CITY HALL LOBBY RENOVATIONS
BID NUMBER: 22-34

ADDENDUM NO. 1

DATE: November 1, 2022

LEVEL 1 DEMOLITION RCP

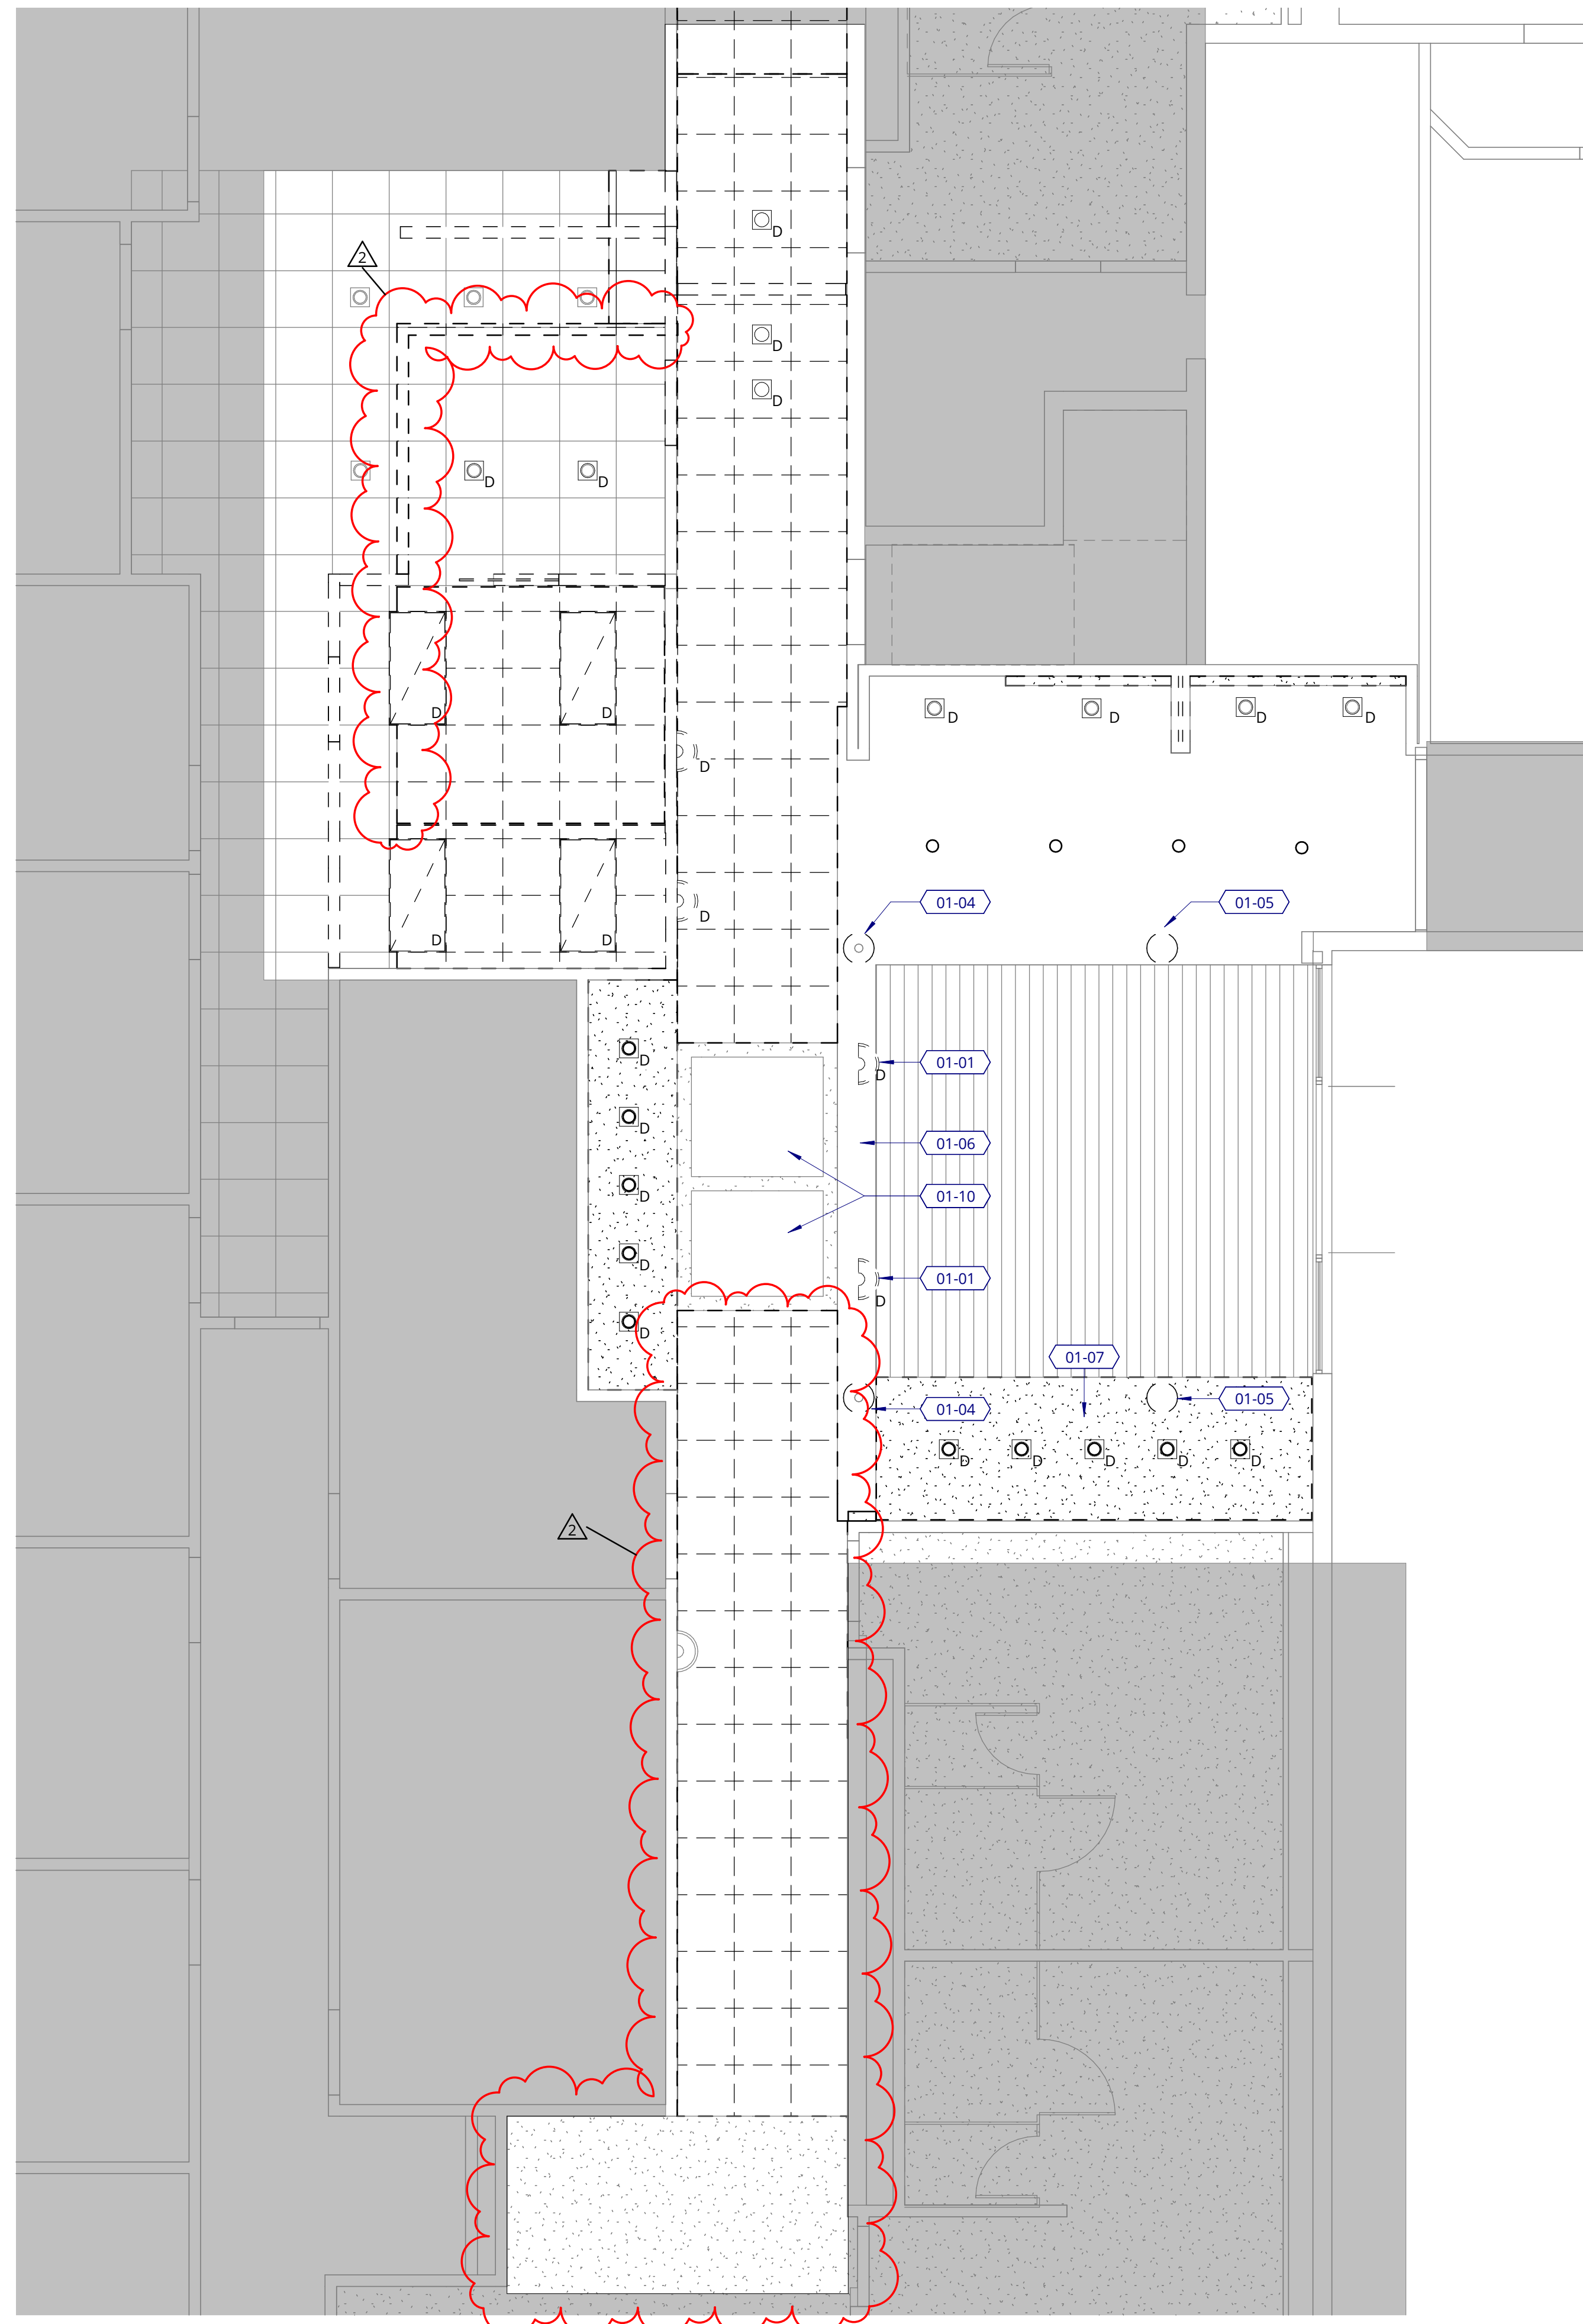
10	What are the work barrier and dust protection requirements?	Contractor must provide all measures necessary to protect adjacent spaces from dust and/or noise, and also provide adequate protection for adjacent property, structures, and passers-by. See Plan Sheet A1.00 Demolition Plan Notes and Section 01 50 00 1.07A of Project Specifications for detailed requirements.

10. **PRICING ALTERNATE: PROVIDE DEMOLITION FOR ROUGH-IN OF NEW SPRINKLER SYSTEM, TO BE INSTALLED IN PHASE 2 OF PROJECT. INCLUDE PRESSURE TESTING FOR SYSTEM AND PROVIDE A TEMPORARY GAUGE ON THE PIPING TO ALLOW TIE-IN TO THE FINAL SYSTEM.**
